VEHICLE RECALL

G-04520

**SUBJECT: SAFETY RECALL (U.S., EXPORT)
MOUNTING BOLTS on IROS equipped 3200, 4200,
4300, and 4400 models built 8/23/2004 thru 10/1/2004**

Figure 1

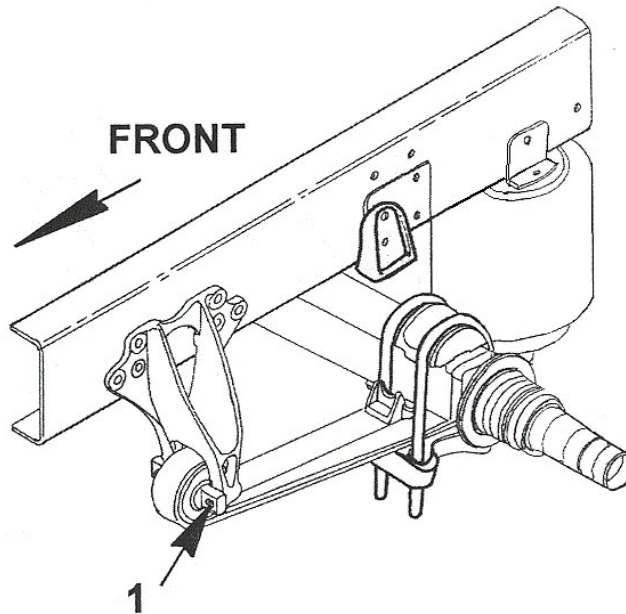
Four rear suspension fasteners may not be tightened sufficiently. This hardware connects the main support members of the rear suspension to the hanger brackets. This connection could fail by the nuts working their way loose or off, or the bolts could break from fatigue. A failure of these fasteners could result in separation of the main support from the hanger bracket possibly resulting in a sudden loss of control of the vehicle. This could cause a **vehicle crash without warning**, possibly resulting in **property damage, personal injury, or death**.

1. Remove one bolt and nut at a time, then install a new bolt and nut.

NOTE: The bolts go through the bushing bar pin in the direction of the arrow with the bolt head against the bar pin (**FORWARD**) and the nut against the hanger (**REAR**). There are two bolts and two nuts required per side.

2. Tighten the new bolt almost to full torque [full torque is **370-460 LbF-Ft (500-625 Nm)**] so that the clamp load will hold the bushing pin aligned while the other bolt is replaced.
3. Repeat step 2 until all four bolts and nuts have been replaced.
4. Finally, fully tighten all four (4) bolts to **370-460 LbF-Ft (500-625 Nm)**.

NOTE: DO NOT REUSE ANY OF THE ORIGINAL BOLTS OR NUTS
